STAFF REPORT ACTION REQUIRED

Application for Fence Exemption 41 Knowland Drive

Date:	April 20, 2009
To:	Etobicoke York Community Council
From:	Curtis Sealock, District Manager, Municipal Licensing and Standards
Wards:	Ward 4, Etobicoke Centre
Reference Number:	ML&S Folder Numbers 08-223969 and 09-119858

1 PLOT PLAN
A1 SCALE: 1/16" = 1'-0"

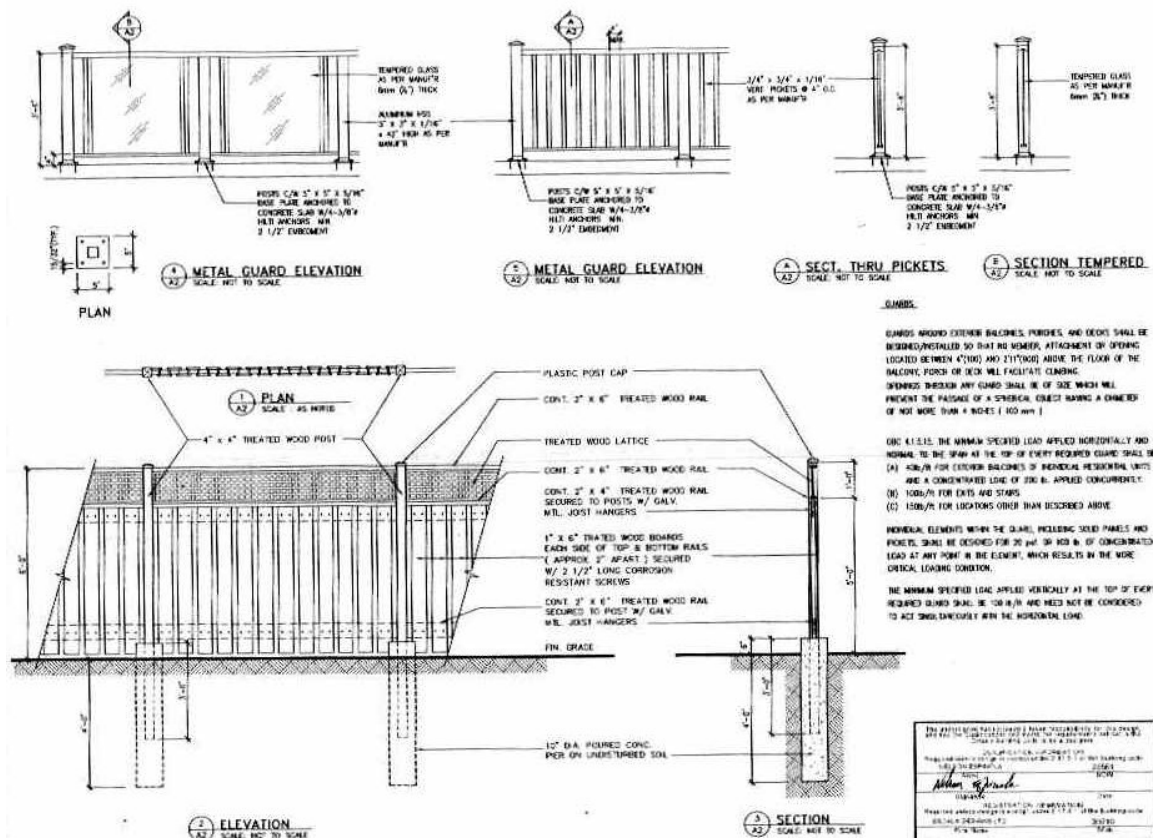
Municipal Licensing and Standards has received a request from the owner of the property for a fence exemption to maintain a section of the pool enclosure in tempered glass construction above a concrete deck, which separates the swimming pool from the residence (Attachments 1, 3 and 4).

Other than this section and the gated entrance to the pool area (which will be constructed in 1.2 metres high metal picket fence, Attachments 1, 2 and 5), the pool enclosure is predominantly made up of a 1.8 metres high close board wood fence with a lattice top.

There is also an existing 1.2 metres high temporary chain link fence built in between the residence and the pool area, which will be removed should this fence exemption be approved (Attachment 4).

1. The tempered glass fence shall be installed in accordance with the Manufacturer’s specification;
2. The rest of the pool enclosure shall be constructed in accordance with the Toronto Municipal Code, Chapter 447, Fences, and Ontario Building Code;
3. Windows sash control devices shall be installed at all windows that form part of the pool enclosure to restrict it from opening more than 100 millimetres, or such windows to be equipped with guards that do not have any openings exceeding 100 millimetres; and
4. Amended drawings shall be submitted and Fence Enclosure Permit to be obtained from Toronto Building Division.
